STAFF RECOMMENDATION 1905 Oakhill Drive February 17, 2016

Application: New construction—infill (Revisions to previously approved plan)
District: Lockeland Springs-East End Neighborhood Conservation Zoning Overlay
Council District: 06
Map and Parcel Number: 08310031700
Applicant: Mitch Hodge, architect
Project Lead: Melissa Baldock, melissa.baldock@nashville.gov

Description of Project: Application is to revise previously approved plans for infill construction on a vacant lot.

Figure 2 (left) is the design approved in 2010, and Figure 3 (right) is the proposed design

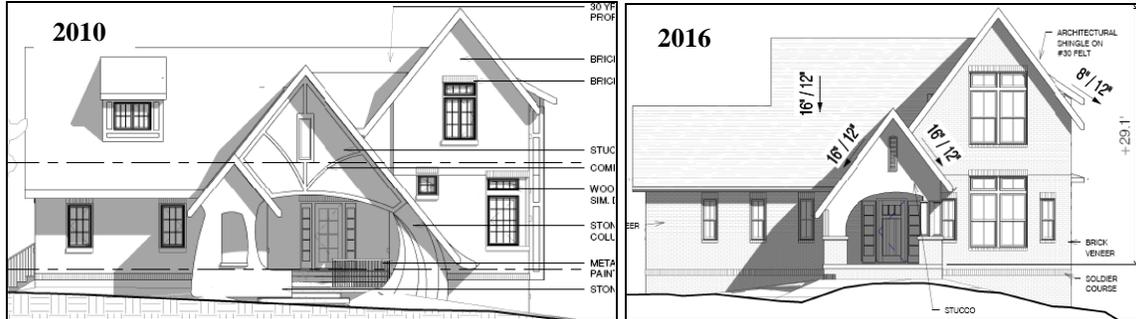
Analysis and Findings: Application is to revise previously approved plans for infill construction on a vacant lot (Figures 2 & 3).

Height & Scale: The house's front façade has three sections. The tallest section is a two-story projecting gable with a fifteen foot (15') eave height and a maximum height of twenty-nine feet (29') from finished floor line. In 2010, the Commission approved a similar two-story projecting gable that was twenty-eight feet (28') from finished floor line, with a sixteen foot (16') eave height. The immediate context consists of one and one-and-a-half story houses, with heights that are between eighteen and twenty-five feet (18'-25') tall, although there are taller houses around the corner on Holly Street. Staff finds that the projecting gable of the proposed house was already taller than the immediate context, and asks that the new proposal be reduced to twenty-eight feet (28') with a fifteen foot (15') eave so that it is no taller than what was previously approved.

The other side gable sections of the front façade have eave heights that are approximately eight feet (8') above the finished floor line and ridge heights that are twenty-five feet, ten inches (25' 10") and eighteen feet (18') above the finished floor line. By comparison, the previously approved design had one continuous side gable section that was twenty-four feet (24') tall, with an eave height of approximately seven feet, six inches (7'6") above the finished floor line. Staff finds that the proposed new side-gabled heights to be appropriate as they help break up the house's massing and meet the historic context.

The lot is one hundred feet (100') wide and two hundred and twenty feet (220') deep. The infill will be forty-nine feet (49') wide at the front. By comparison, the previously approved design was fifty-three feet (53') wide, and the houses in the immediate vicinity are between forty-five and sixty feet (45'-60') wide. Staff finds that its width meets the historic context. The infill will have a footprint of approximately two thousand, two hundred and ten square feet (2,210 sq. ft.), which is comparable to the footprint that was previously approved.

With the reduction of the height of the tower to twenty-eight feet (28') from finished floor line, staff finds that the project meets Sections II.B.1. and II.B.2. of the design guidelines.

1. The projecting gable be reduced in height so that it is no taller than twenty-eight feet (28') from the finished floor line, the height of the previously approved plan;
2. The finished floor height shall be consistent with the finished floor heights of the adjacent historic houses, to be verified by MHZC staff in the field;
3. Staff approve the final details, dimensions and materials of windows and doors prior to purchase and installation;
4. Staff approve masonry;
5. Staff approve the roof color;
6. New drawings be submitted showing the removal of wall dormers;
7. The HVAC shall be located behind the house or on either side, beyond the mid-point of the house; and
8. A front walkway be added from the street to the front porch.

1 1905 OAKHILL DRIVE
 A-1 1" = 30'-0"

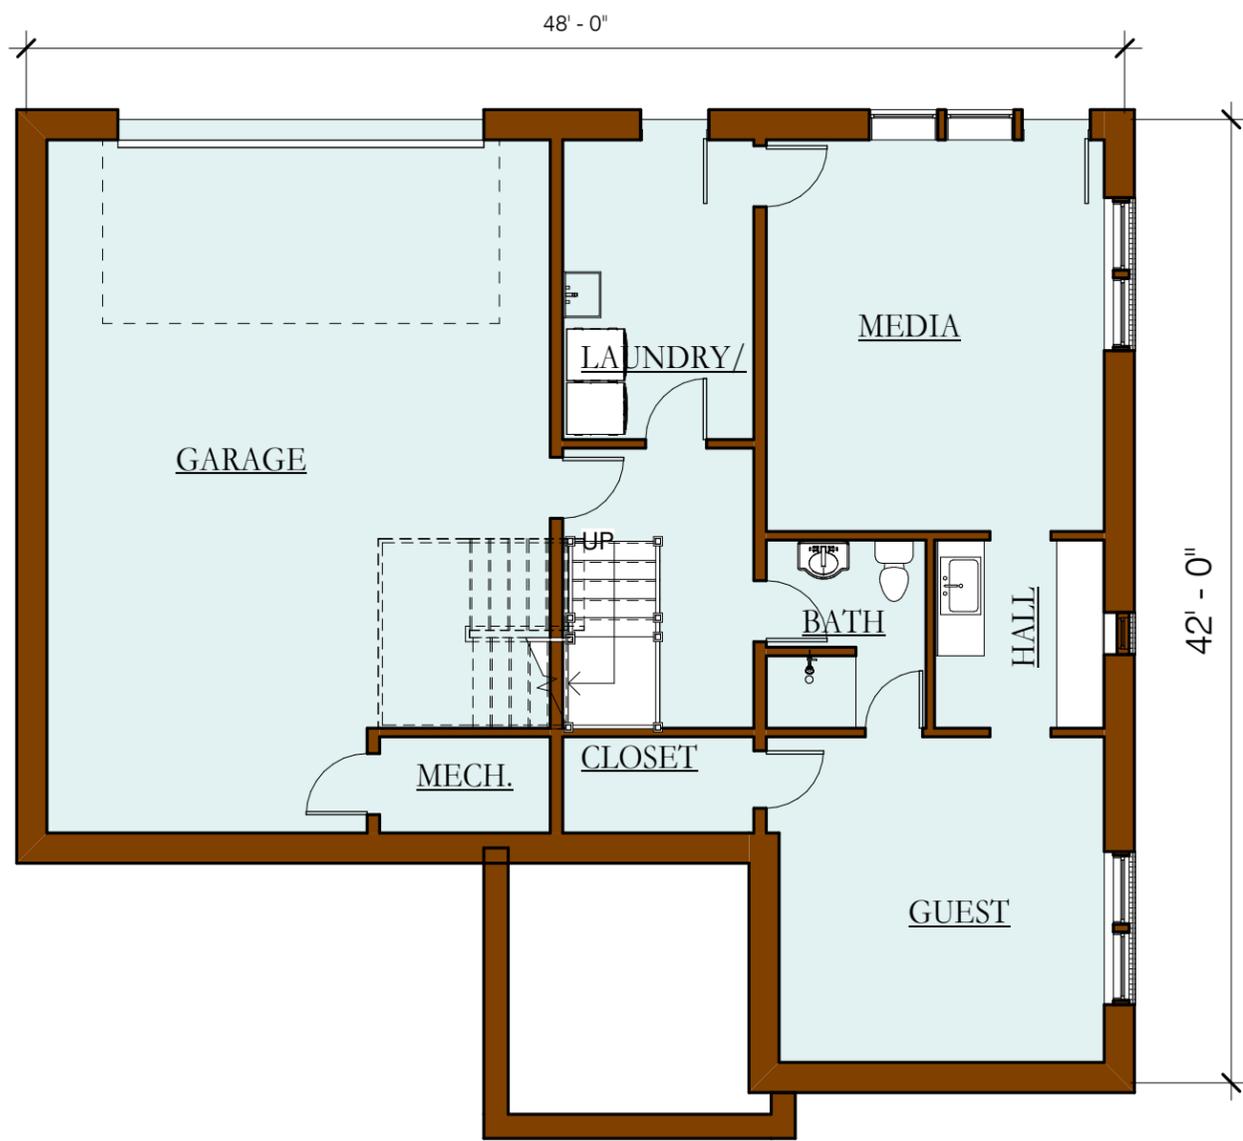
Setback & Rhythm of Spacing: The proposed infill will meet all base zoning setbacks. It will be twenty-five feet (25') from the left side property line, twenty feet (20') from the right side property line, and nearly one hundred feet (100') from the rear property line. Its front setback will be approximately sixty-seven feet, ten inches (67'10"), which is the same as was previously approved and is the average of the two adjoining setbacks. Staff finds that the project meets Section II.B.3. of the design guidelines.

Orientation: The house is oriented towards Oakhill Drive, which is appropriate. There is a single entry door behind a twelve foot (12') deep, partial width front porch. Vehicular access to the site will be via an existing driveway to the right of the lot. Staff recommends inclusion of a front walkway from the street to the front porch. With the addition of the walkway, staff finds that the project's orientation meets Section II.B.6. of the design guidelines.

Appurtenances & Utilities: No changes to the site's appurtenances were indicated on the drawings. The location of the HVAC and other utilities was also not noted. Staff asks that the HVAC be located on the rear façade, or on a side façade beyond the midpoint of the house.

1 FRONT
A-3 1/8" = 1'-0"

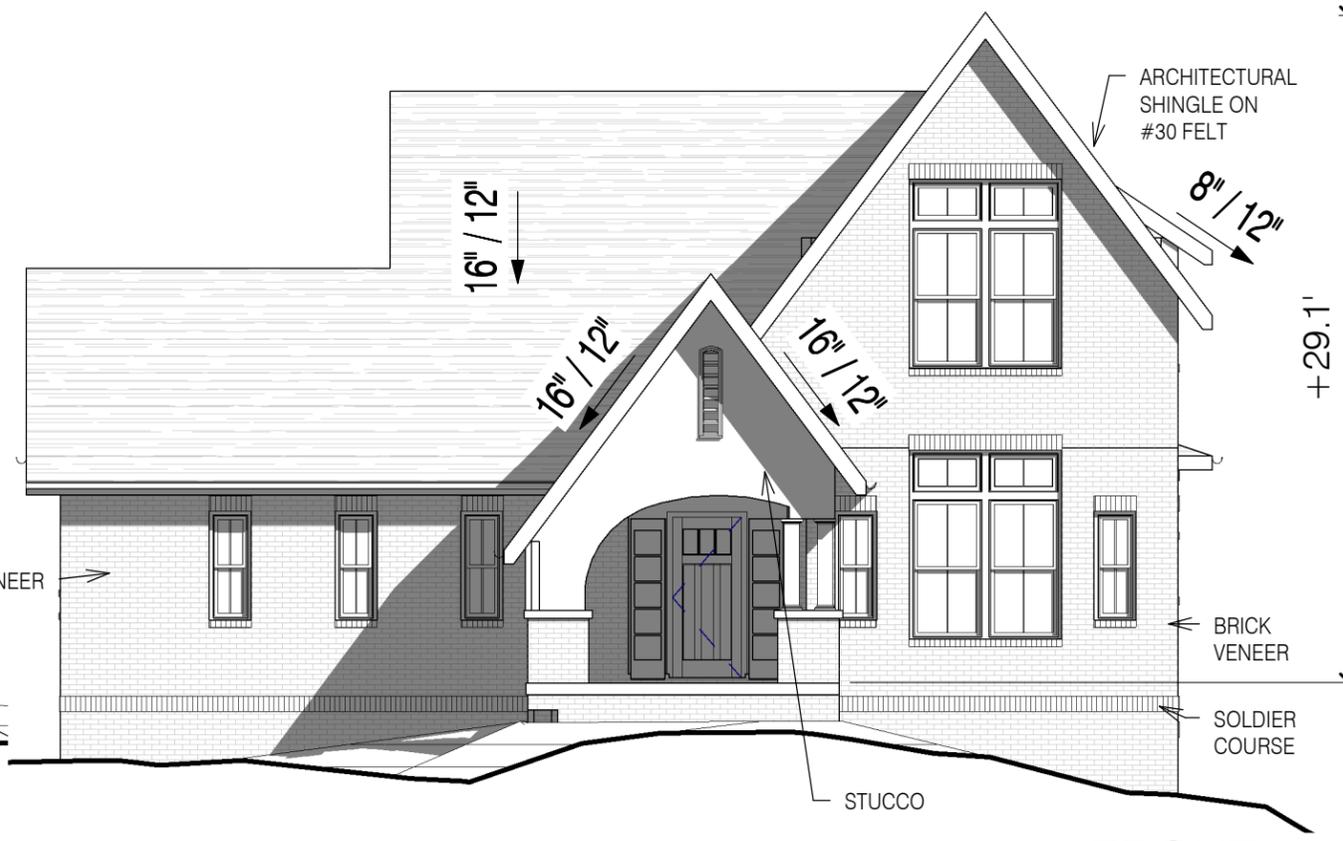
Roof form: The house's roof includes a series of gables with 16/12 pitches. The front gabled tower and the front porch's gable will also have 16/12 pitches, and the left elevation includes a 5/12 hipped roof form. Staff finds the primary roof forms to be appropriate.
